Retrofit the Trunk Lid Harness

SB-21-17-008
April 30, 2022

Figure 1 – Coaxial cable with yellow stripe

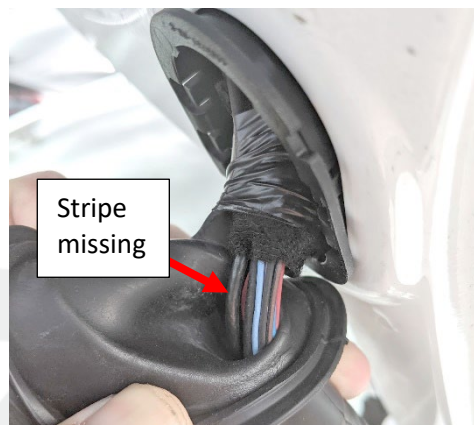
2. Release the rubber armor from the trunk lid, and inspect the coax cable within the armor (Figures 1 and 2).
 - **If the coax cable has a yellow stripe** - Replace the trunk lid harness (refer to Service Manual procedure [17104502](#)). Discontinue this procedure and use correction code S022117008.
 - **If the coax cable is all black** - Fasten the rubber armor to the trunk lid and go to the next step.

Figure 4 – Cut push mount tie on dotted line

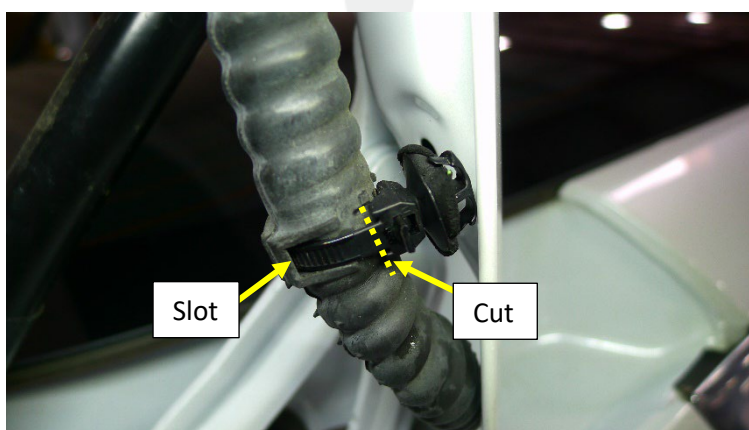
4. Use diagonal cutters to carefully cut and remove the old push mount tie from the rubber armor (Figure 4).

Figure 6

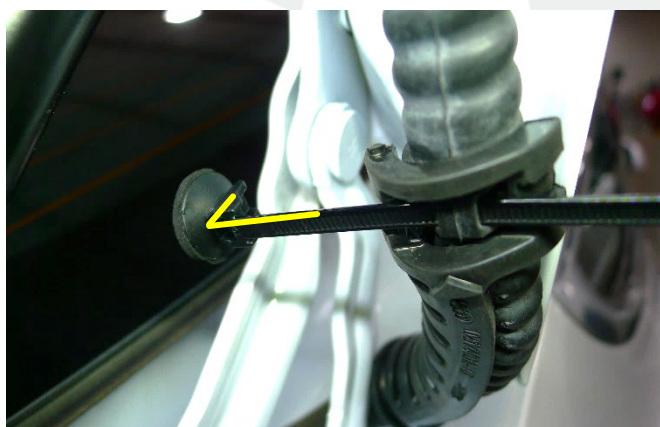
6. Thread a new push mount tie through the slot in the rubber armor (Figure 6), wrap the tie around the grommet support and rubber armor, and then loosely fasten the tie (Figure 7).

**NOTE:** Pay close attention to how the push mount tie threads into the slot in Figure 6.
